Re: Application review, FCC ID: OVFKWC-K4X3

Thank you for your feedback on the FCC application that I have submitted. Please find my responses to your questions below.

Appendix A

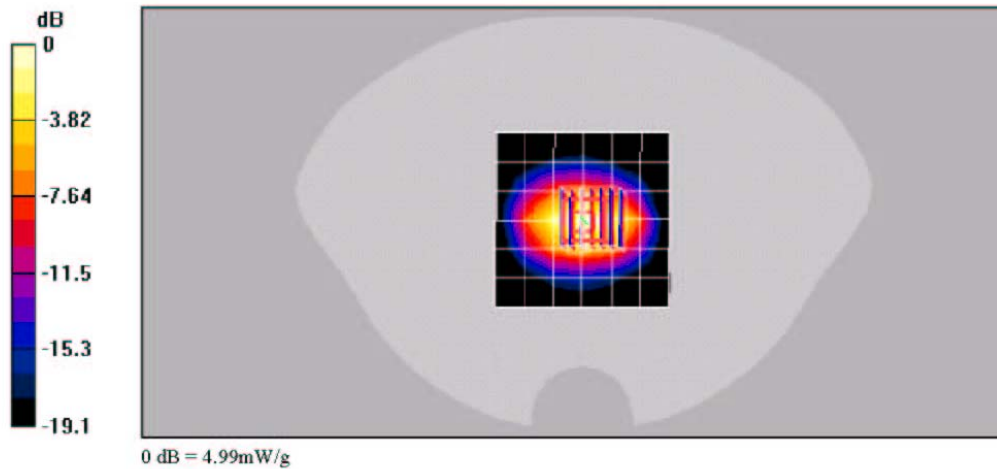
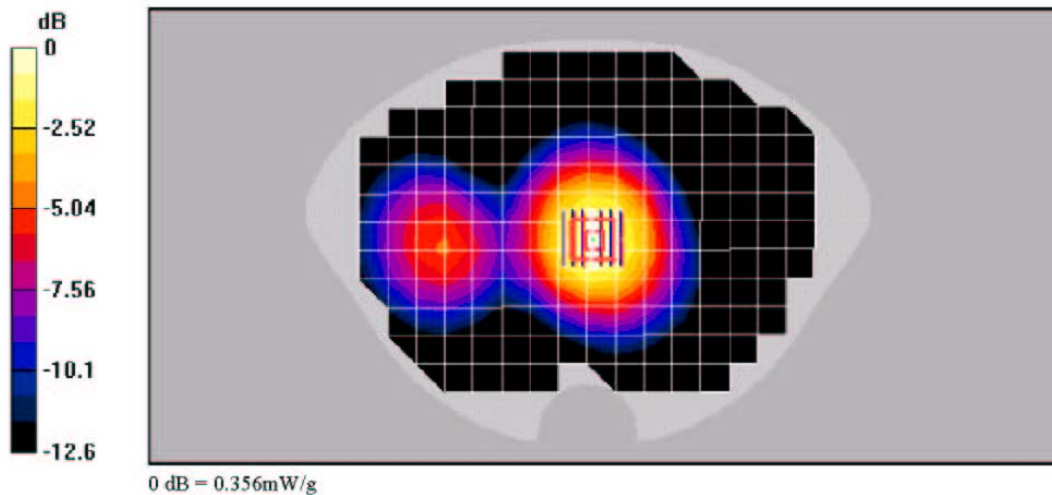
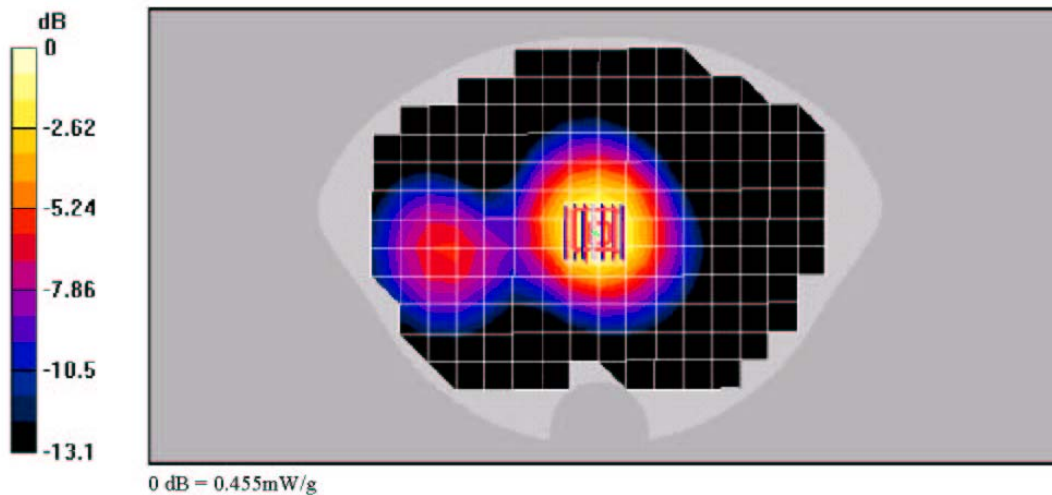
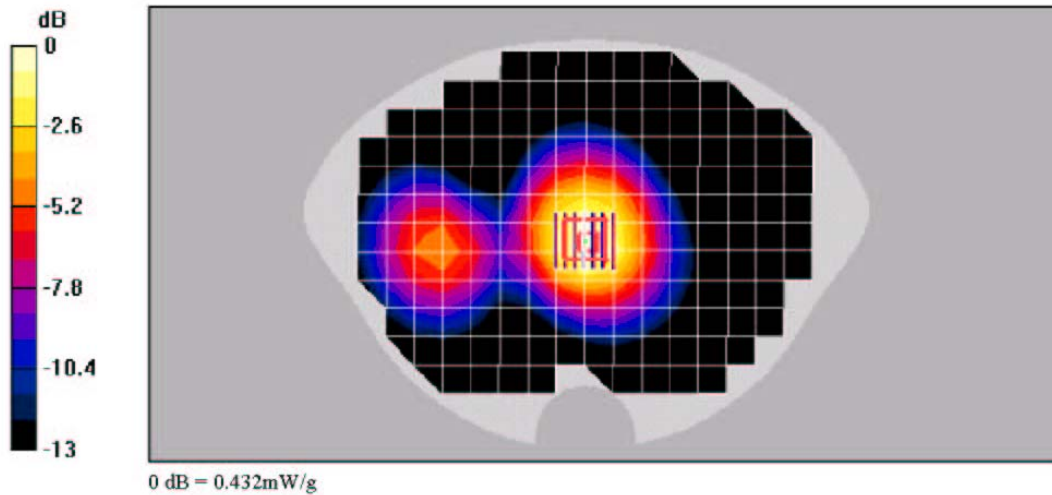
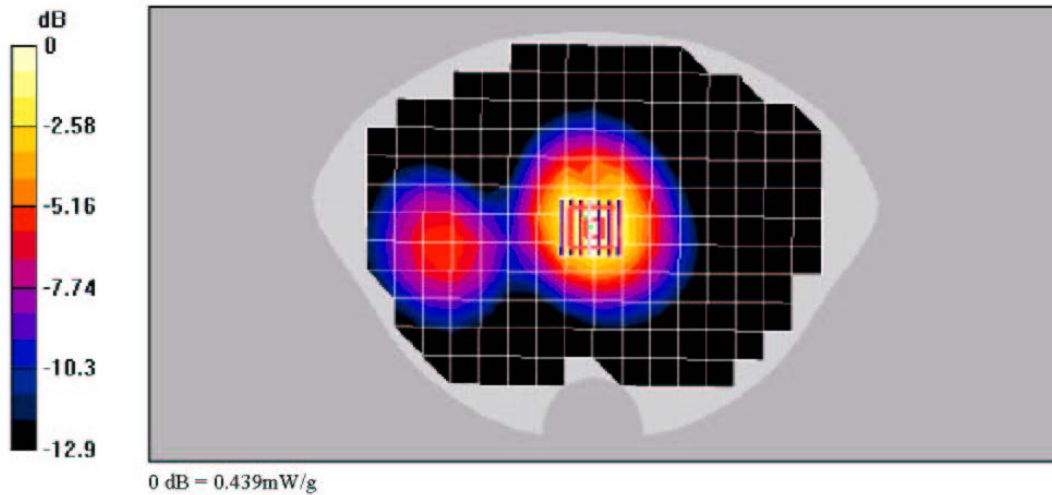
b) I could not locate Probe calibration for body (ConvF(5, 5, 5)). On the SAR graphs for body, it is written "Probe not calibrated". Please explain.

The probe in question, serial number 1772, was last calibrated on 10-10-2003. Previous to 10-10-2003 the probe was calibrated for both head and body. The probe vendor was contacted and it was found that when the probe was re-calibrated on 10-10-2003, only head calibration was performed. Therefore, the calibration certificate date for body testing using probe 1712 has expired. The body testing that occurred used the calibration factors that were valid up to 10-10-2003.

The SAR values that were tested using probe 1712 were verified to be valid by re-testing the worse-case positions using another probe, serial number 1663, which has valid calibration for both head and body. The re-test data taken with probe 1663 on 7/14/2004 was found to be equivalent with the original reported data that was taken with probe 1712 on 6/14/2004 and 6/15/2004. The SAR results were within 0.085 mW/g of the original values. Please see Appendix A of this correspondence for the 7/14/2004 validation plot and the re-test data of the worse case position plots.

Appendix B

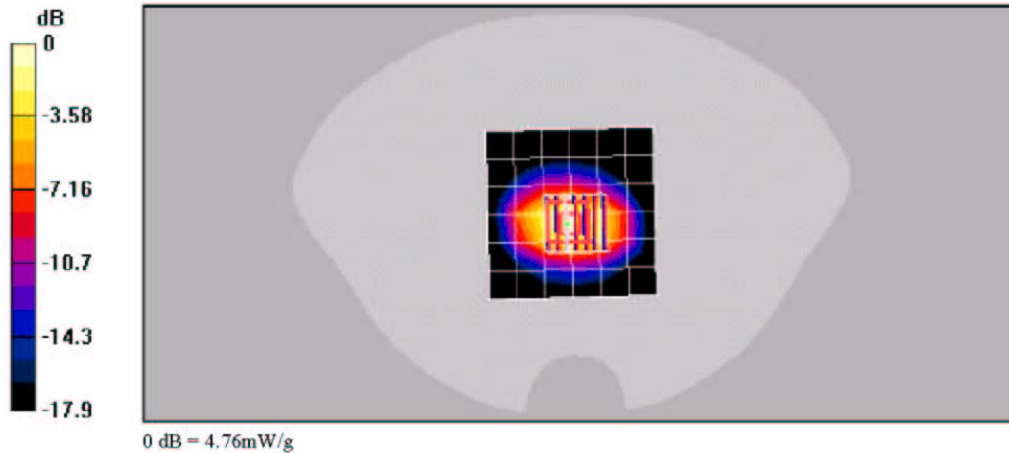
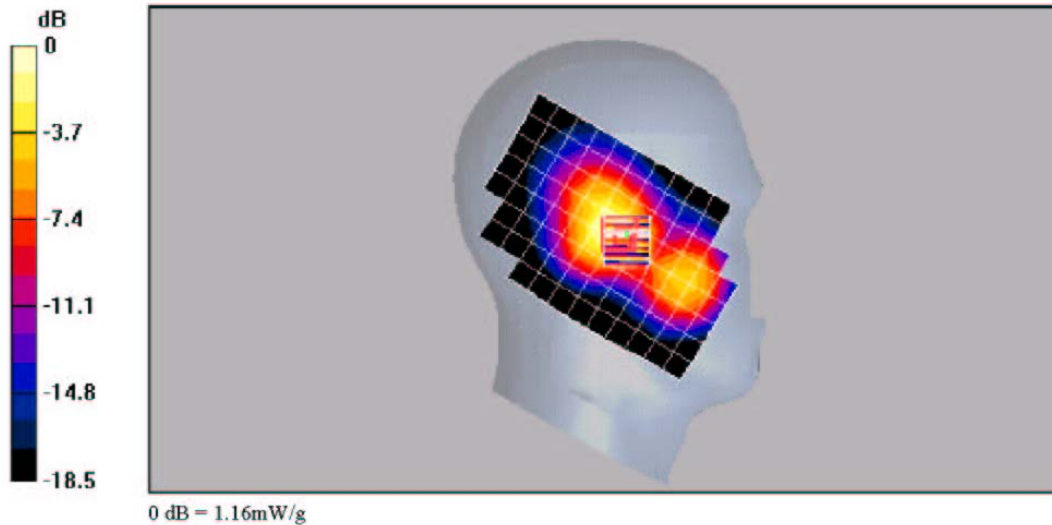
c) Please comment the low level of the validation SAR (3.81 mW/g on 6/2/04 and 3.8 mW/g on 6/03/04) which is 19.7% lower than SPEAG reference level (page 11 of the SAR report) - FCC requirement is 10% max.

The system validation data from 6/2/2004 and 6/3/2004 data was checked. The liquid parameters have been found to be correct for that day. It appears that the positioning of the dipole under the phantom must have been slightly incorrect when performing the validation test. If the positioning of the dipole is not correct, then the validation SAR values that are measured may become out of tolerance.

The SAR data for the phones tested 6/2/2004 and 6/3/2004 was verified and found to be correct by re-testing the worse-case position again on 7/15/2004. The delta of the worse-case SAR results were within the 10.32% combined standard uncertainty of each other. Please see Appendix B of this correspondence for the 7/15/2004 validation plot and the re-test data of the worse-case position plot.
